# 2 Angel Square

Planning Addendum - MMA

August - 2024

Planning Review

# GA Plan - LG Floor - Comparison

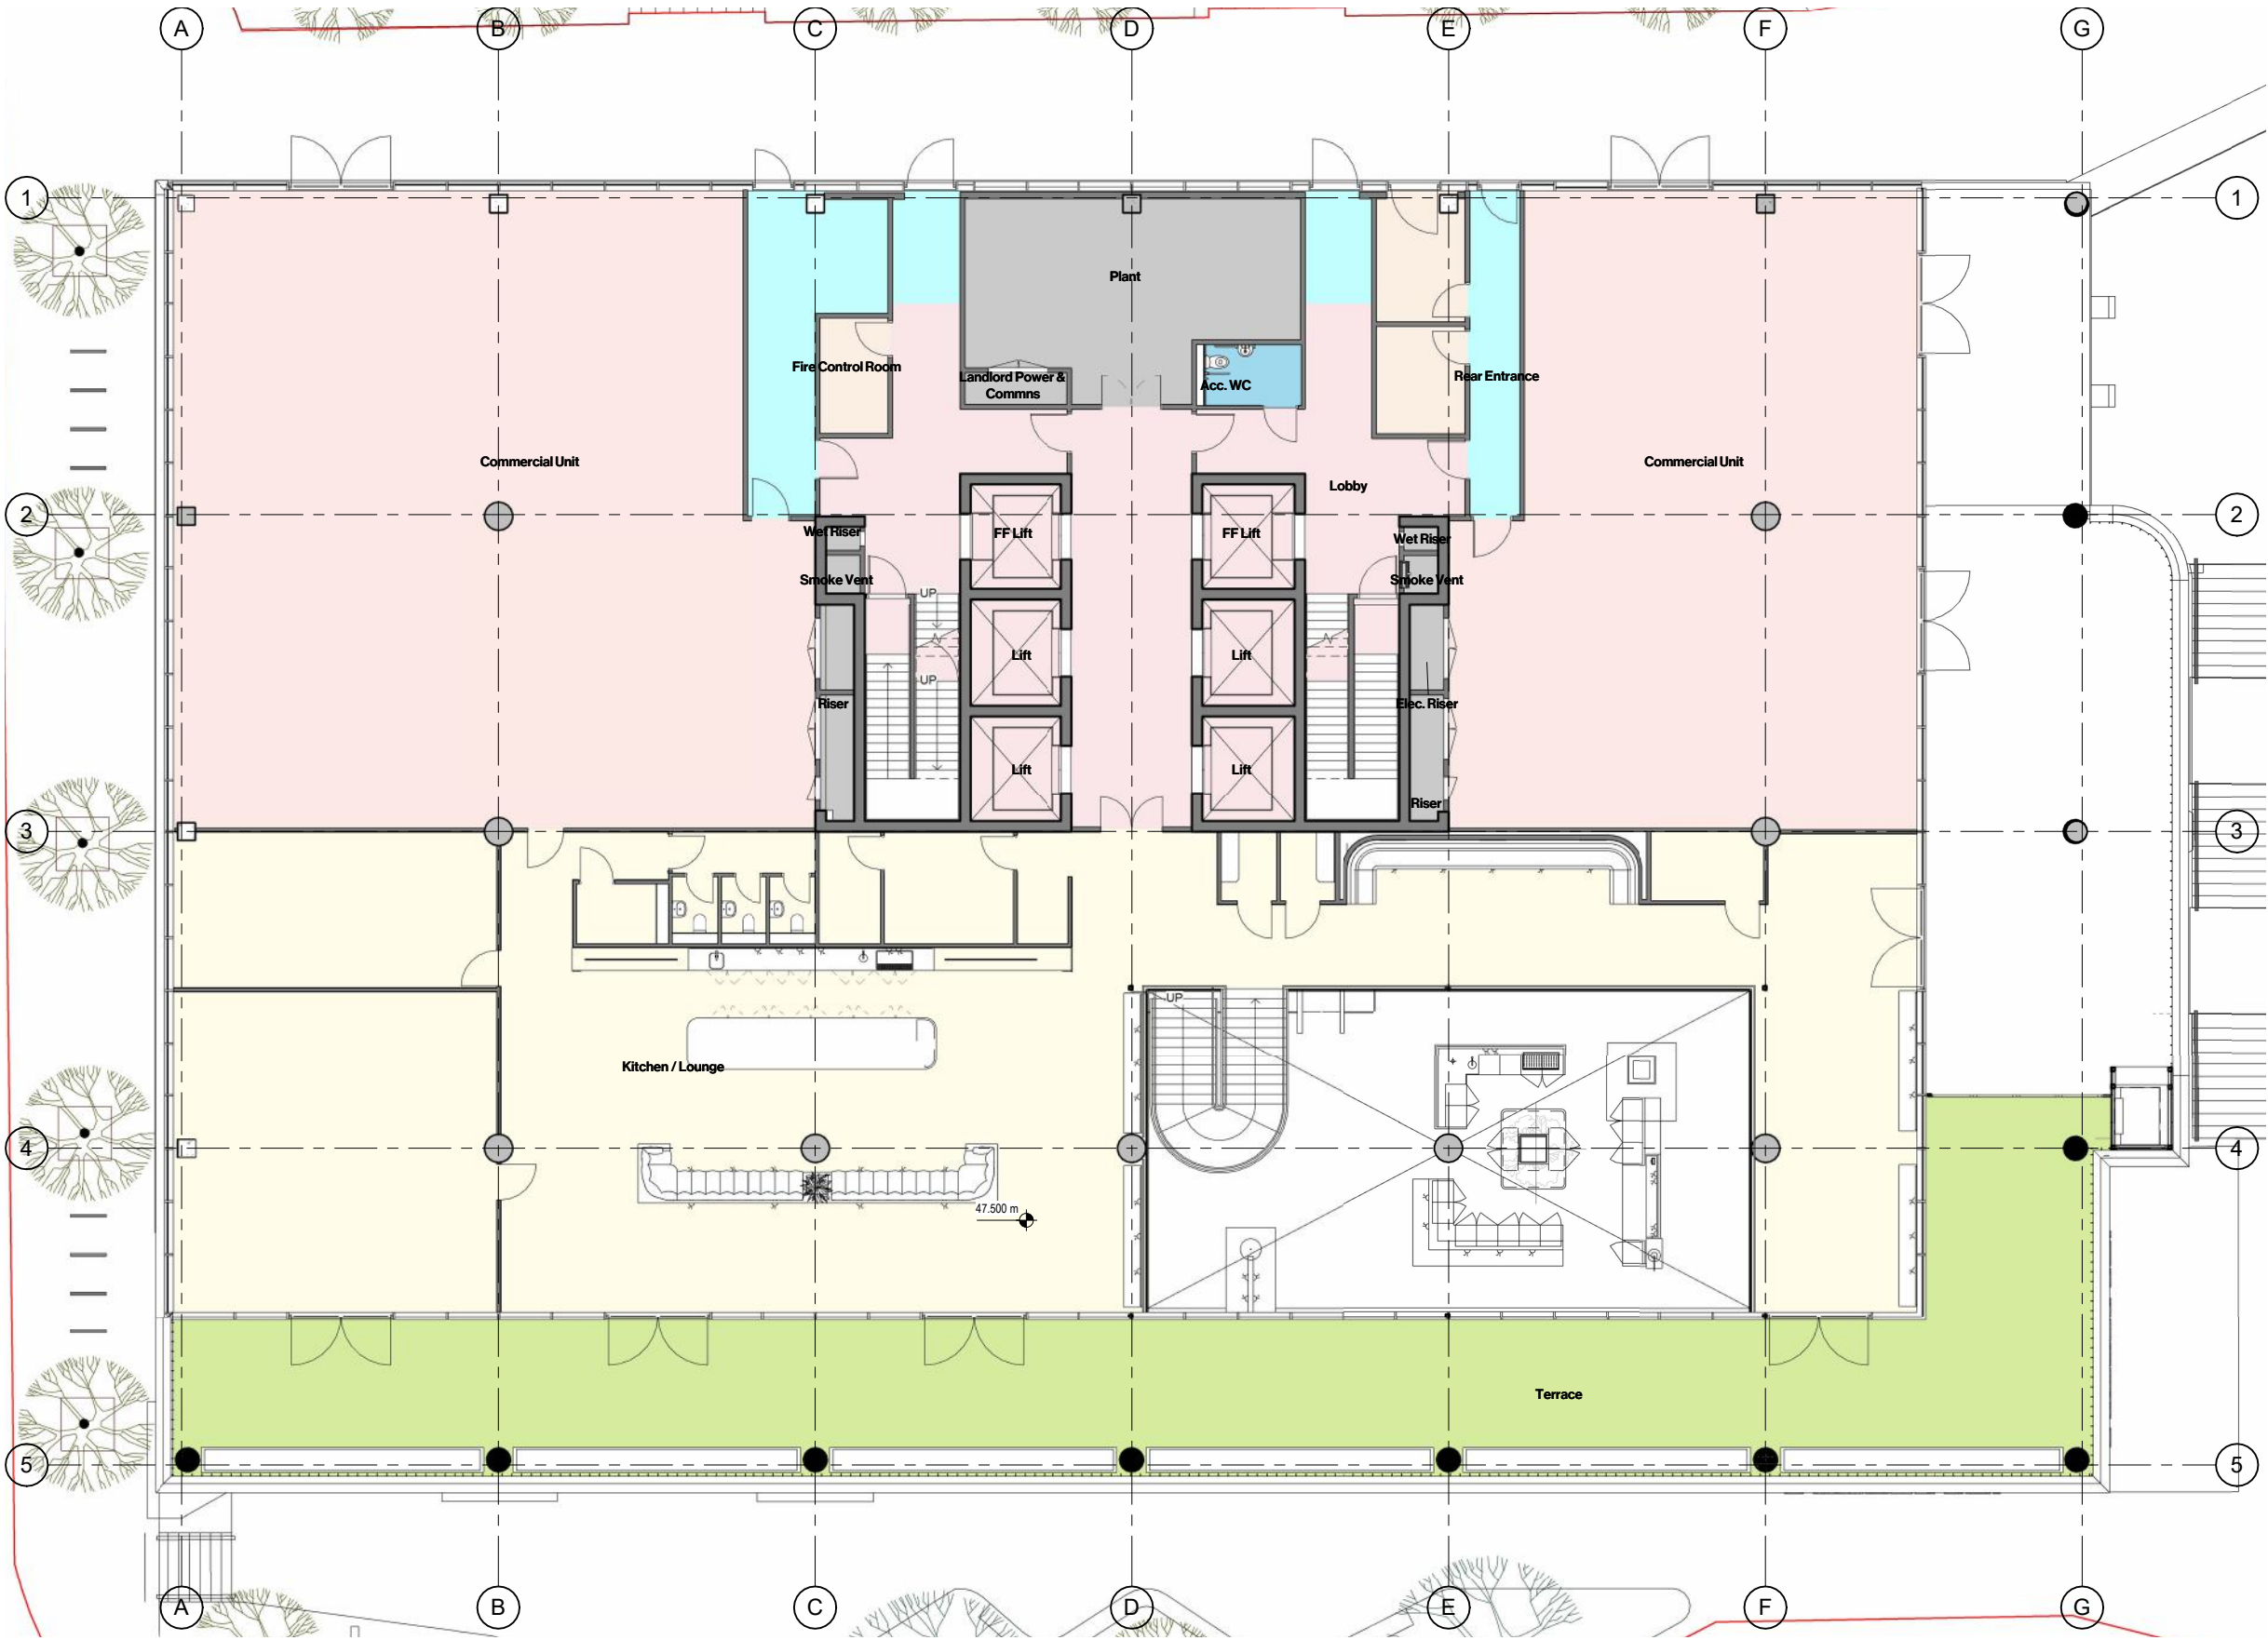
1. Car Park - Layout adjustment. Number of car parking spaces reduced to 14 (including 2 EV & 2 Disabled) + 2 (Motorcycles) (Planning: 15 Cars + 3 Motorcycles)
2. Cycle store - Layout adjustment. Number of cycle spaces increased to **180 No Total**. (Planning: 108)  
18 No Folding Bike lockers  
96 No Semi-vertical Bike Rack  
36 No Type A - Sheffield  
6 No Type B Recumbent  
24 No 2-Tier racks
3. Pump Room increased in size.
4. Changing room layout adjusted. Number of showers increased to **18 No Total** (Planning: 12 No total)  
16 No standard cubicles + 1 No multi-purpose room & 1 No Accessible
5. Locker arrangement adjusted. Number of lockers increased to **191 No total** (Planning: 158 No)
6. Introduction of lobby to changing rooms and access route from main reception
7. Location of accessible WC and seating arrangement updated.

2. 2 Angel Square August 2024  
GA Plan - UG Floor

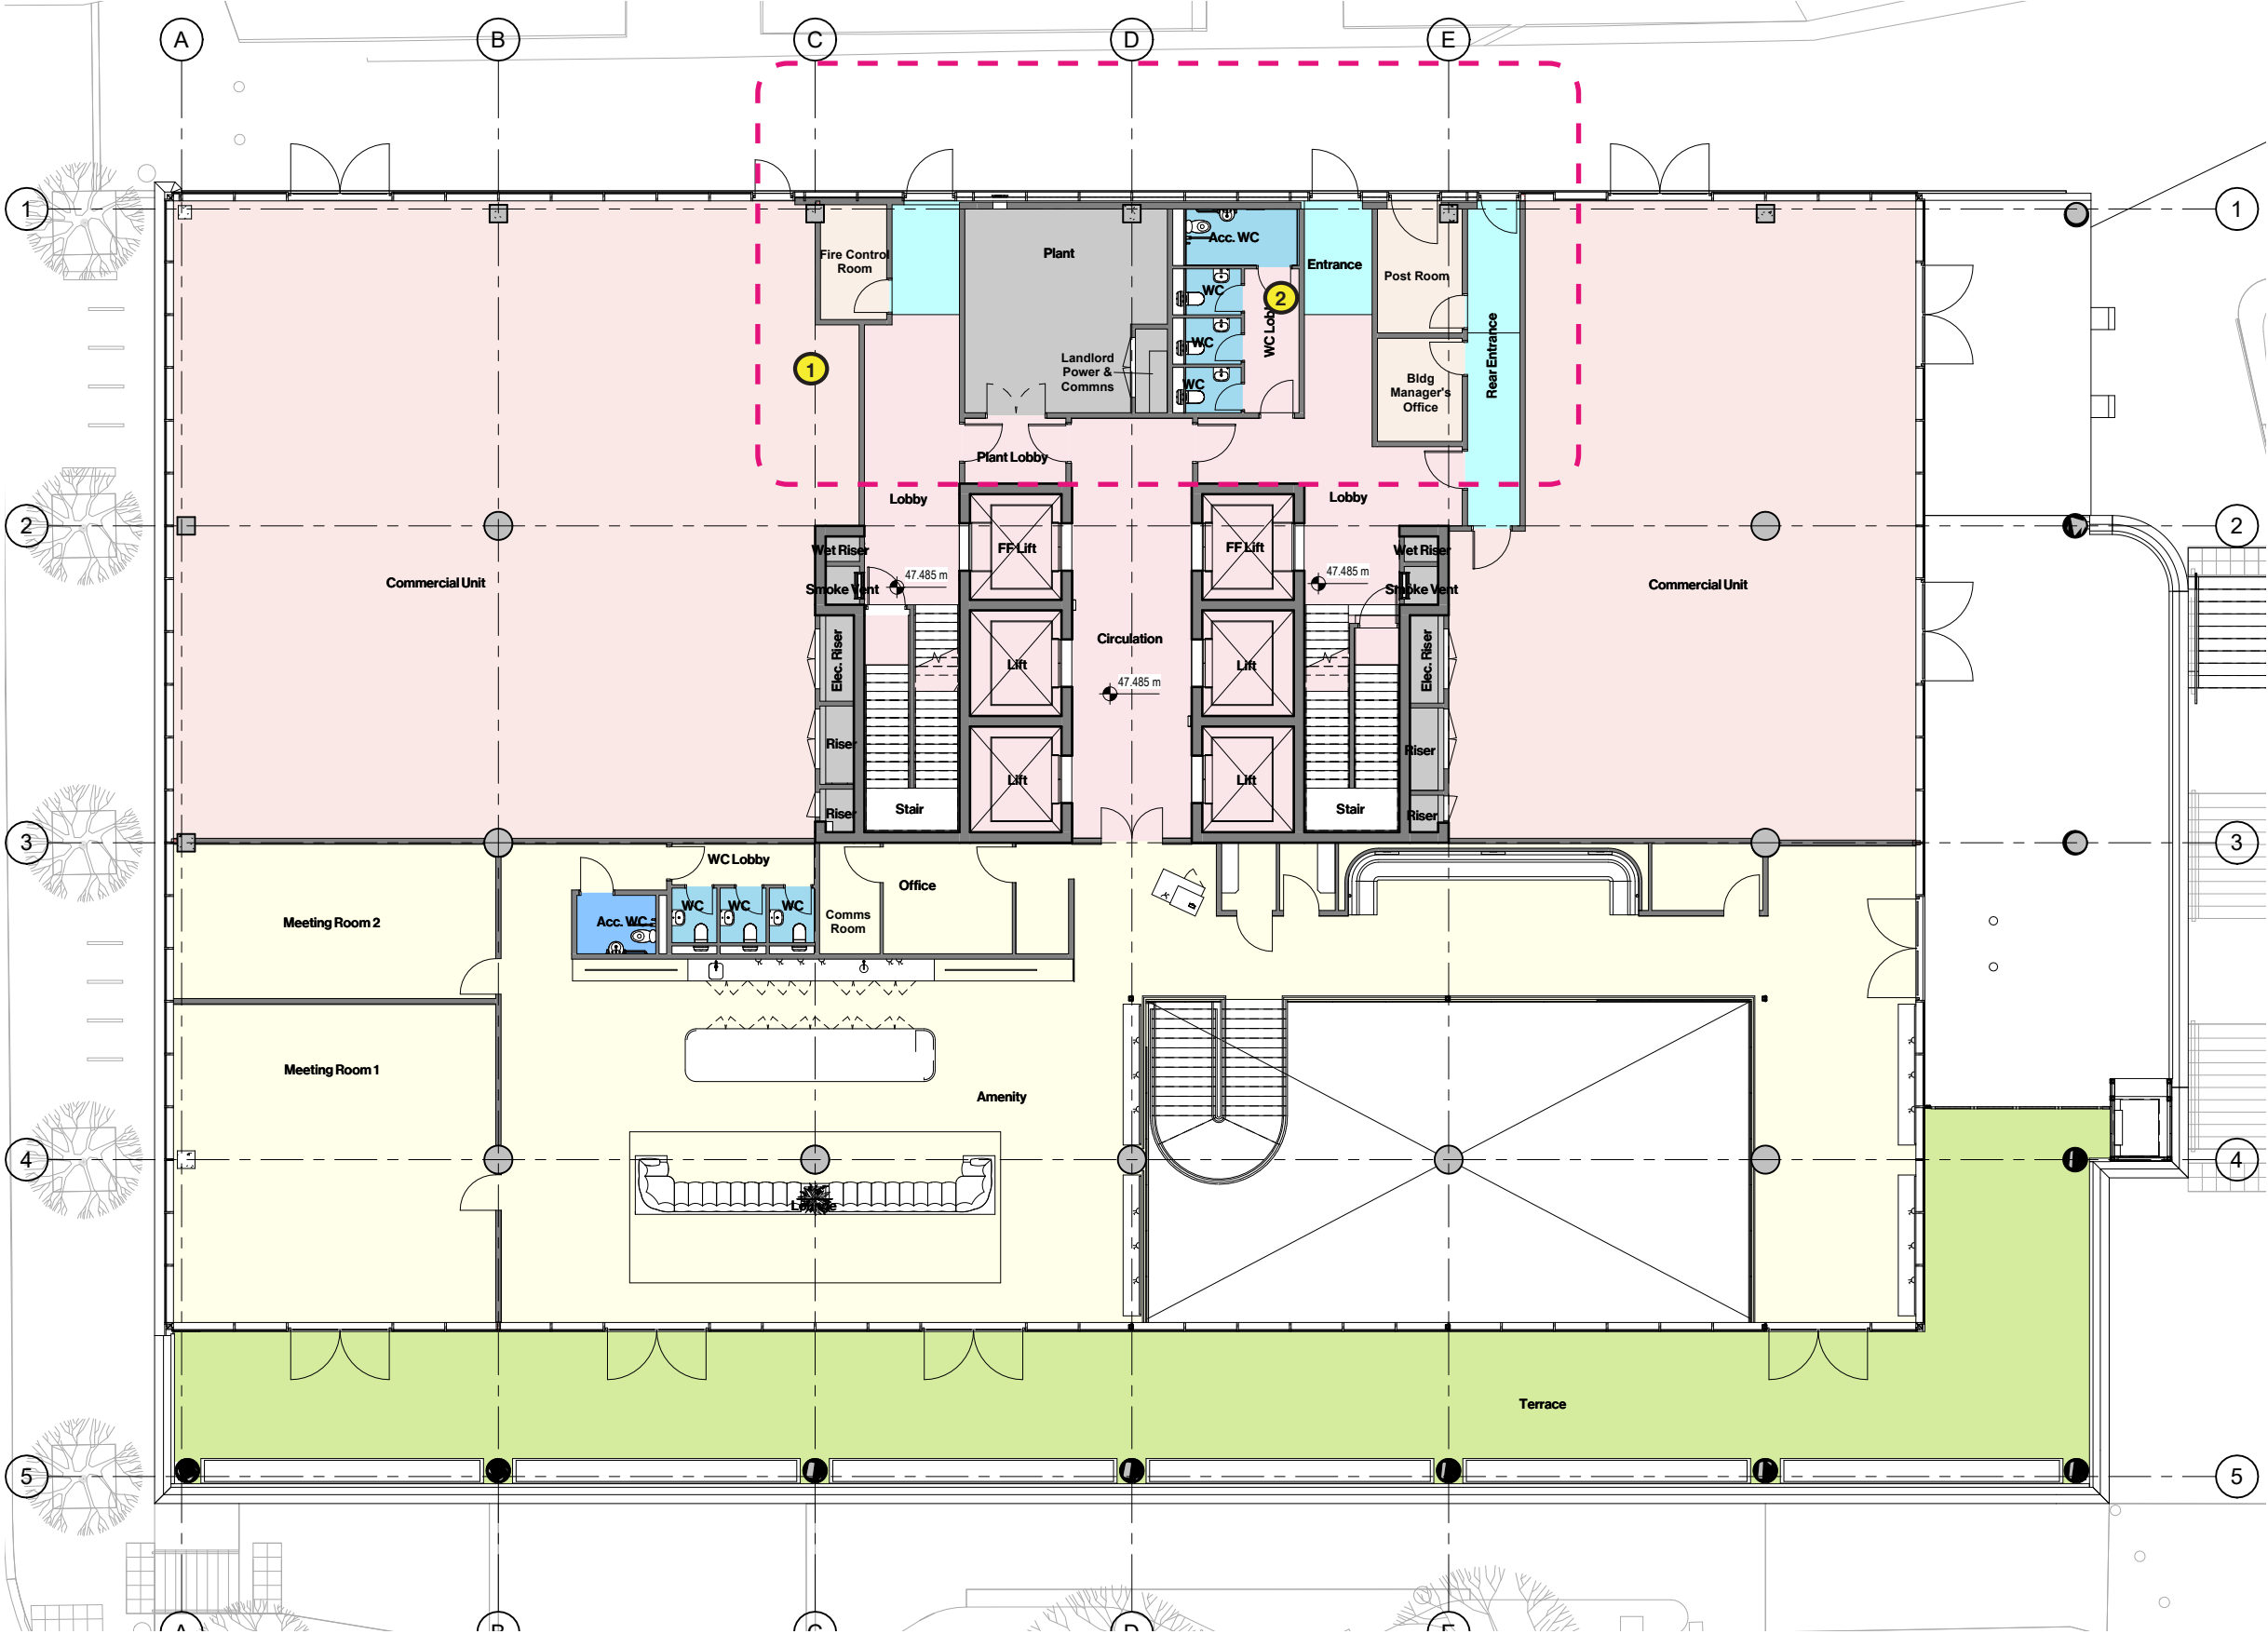
- 1. Isolated access route through commercial unit to core lobby omitted.
- 2. WC provision added to core arrangement.

# GA Plan - Typical Floor

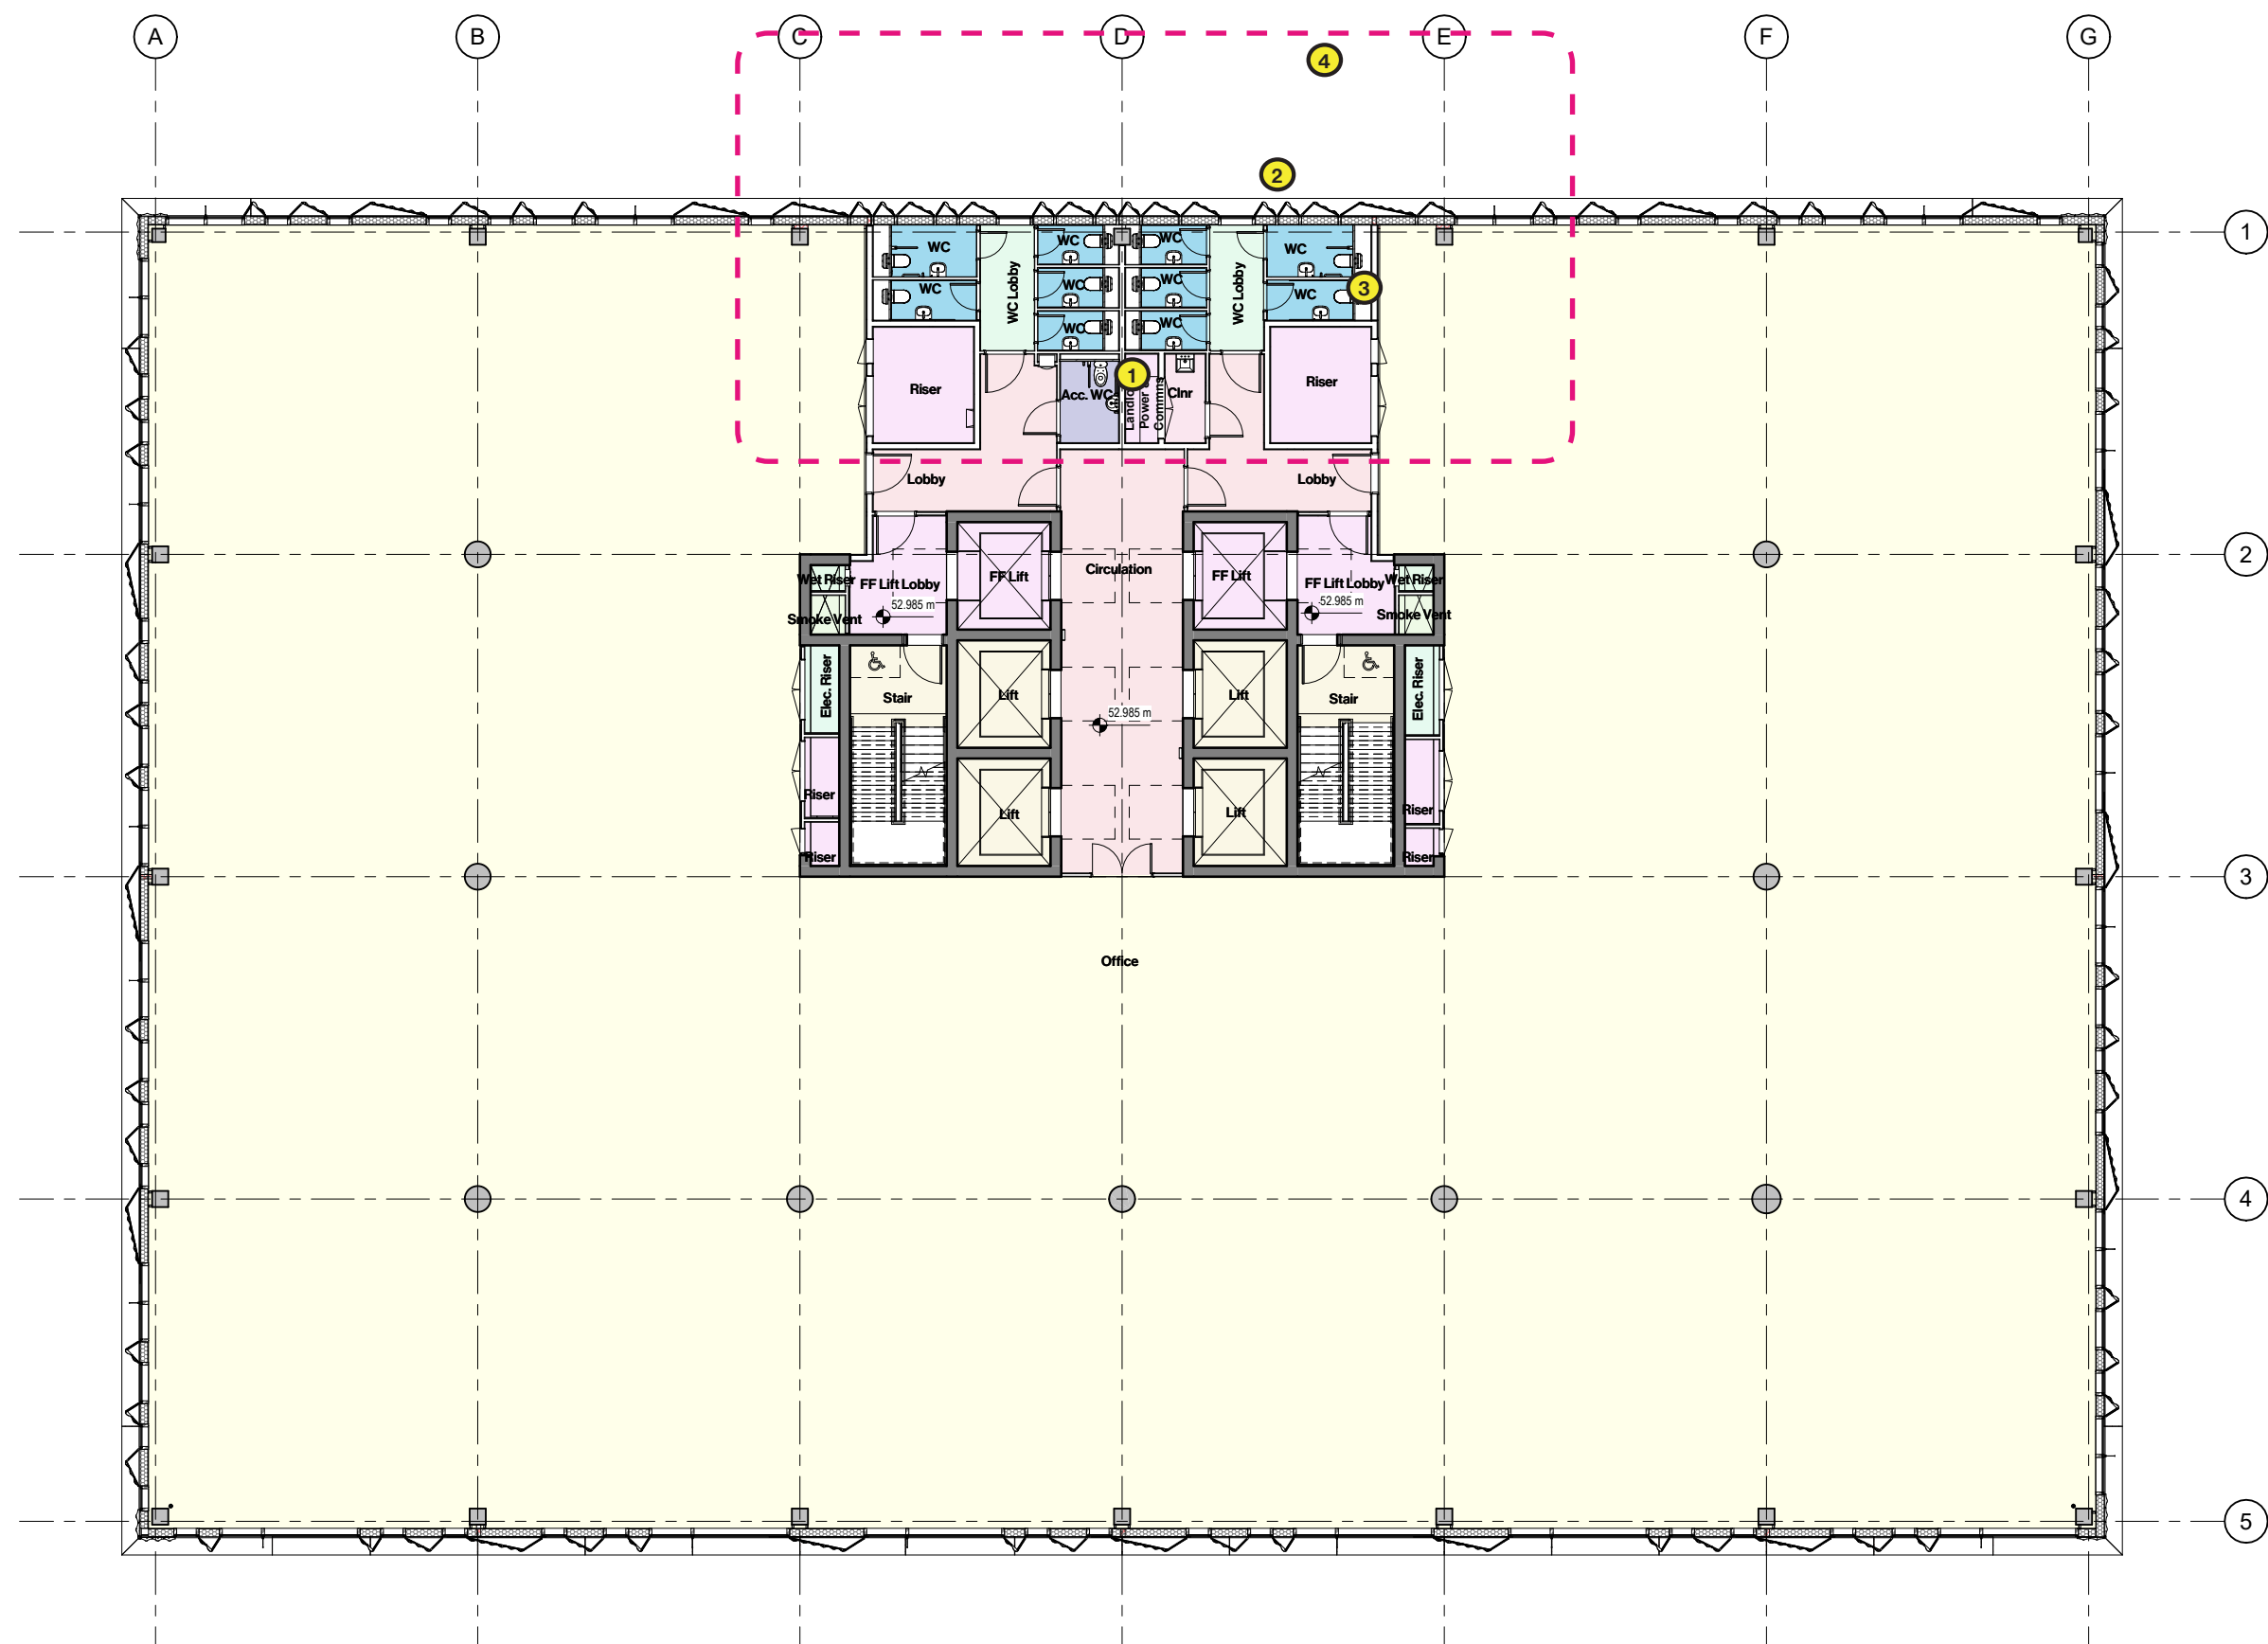
- Proposed**
- 1. On floor plant room omitted.
  - 2. WC layout amended.
  - 3. AHU risers added.
  - 4. External envelope configuration amended to suit layout changes.
